Valley Pool Renovation

no.	date	revision
1	4/17/91	RECORD DRAWINGS

Valley Pool Renovation
Parks & Recreation
City of Albuquerque (City Project No: 2854)

Cover Sheet & Project Data

Alternates

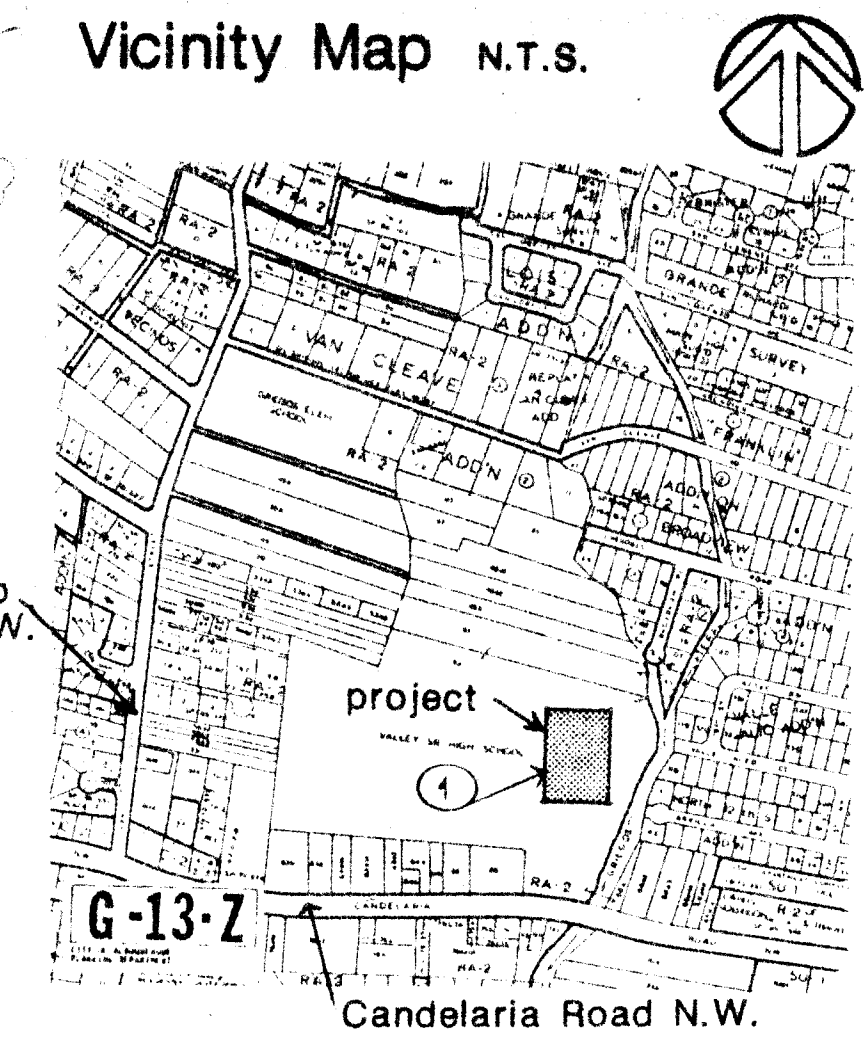
BOTH ALTERNATES TAKEN

WADING POOL NOT REPLASTERED

Site/Roof Plan
1" = 20'-0"

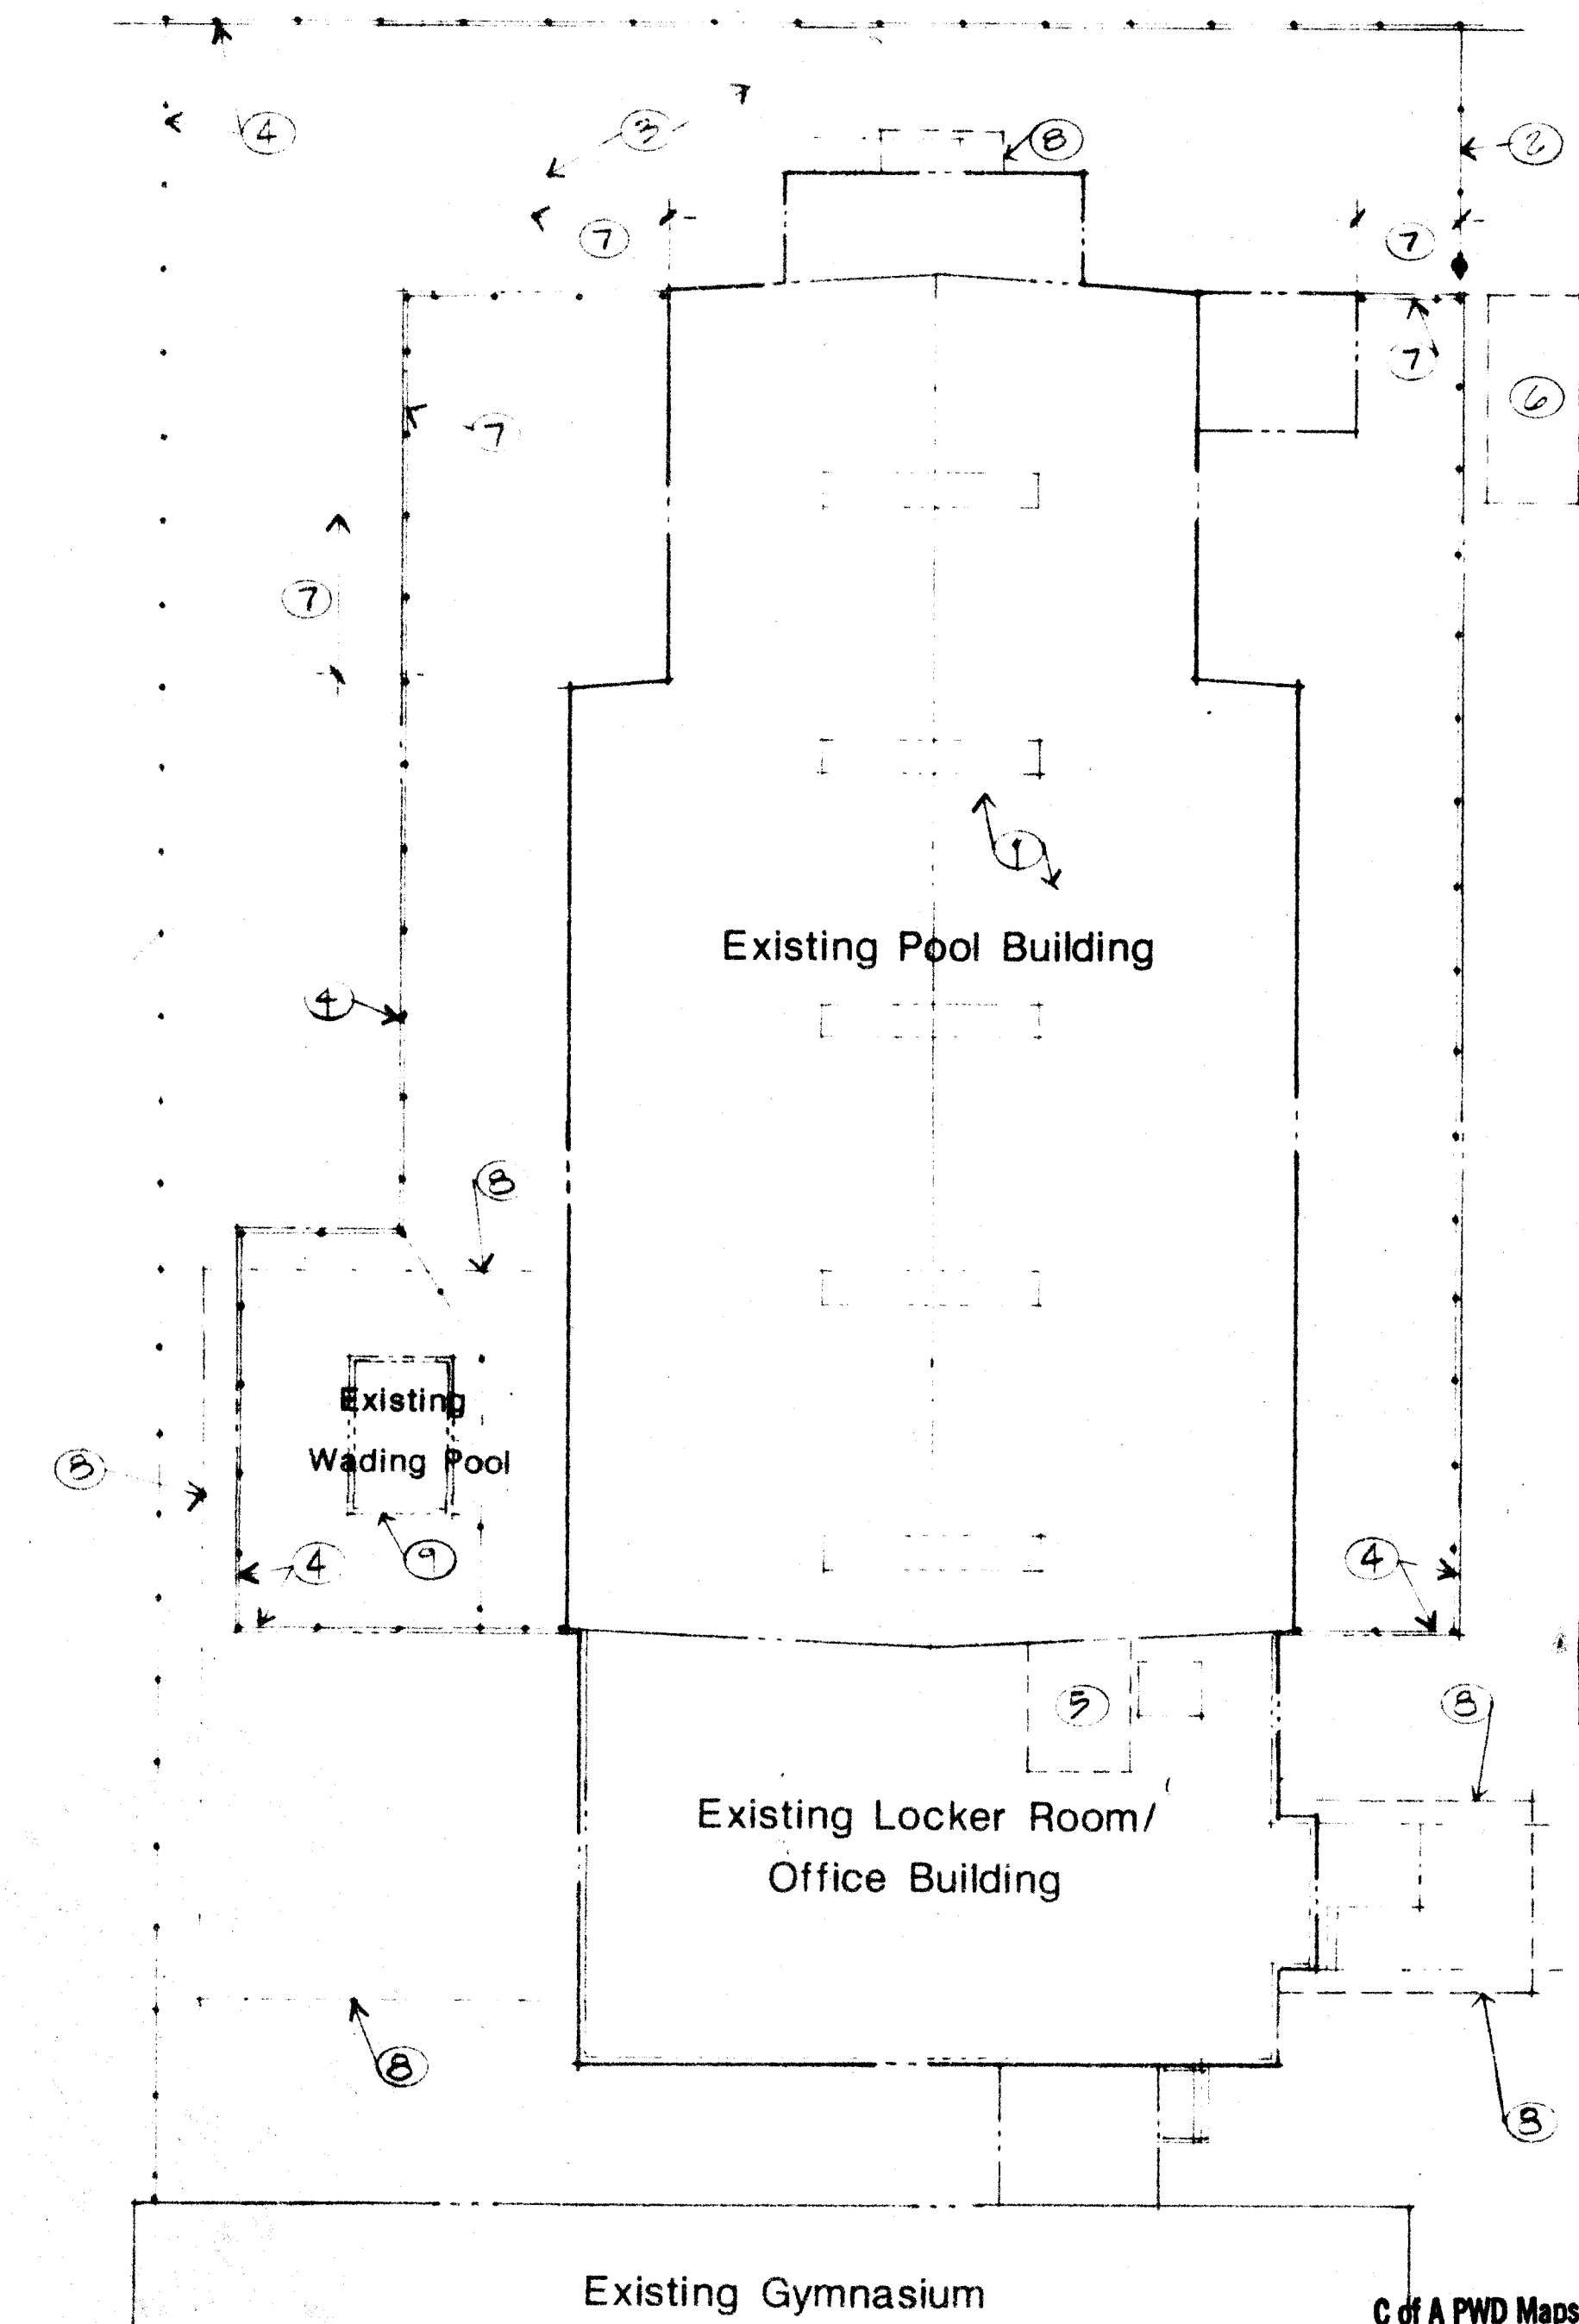
EXISTING ASBESTOS CONTAINING
"TRANSGITE" BOARD ABOVE
EXISTING OVERHEAD DOORS
REMOVED

ALL ASBESTOS CONTAINING
GYPSUM BOARD CEILINGS
REMOVED IN LOCKER ROOMS,
INSULATION & LIGHT FIXTURES
ABATED AS WELL

REMOVE & REPLACE H.M.
DOOR & FRAME

REMOVE & REPLACE CONCRETE POOL
DECK AS REQUIRED FOR POOL
PUMP INSTALLATIONS. REPLACE
ALL LADDER, PLATFORM AND
PLAS SLEEVES, TYPICAL
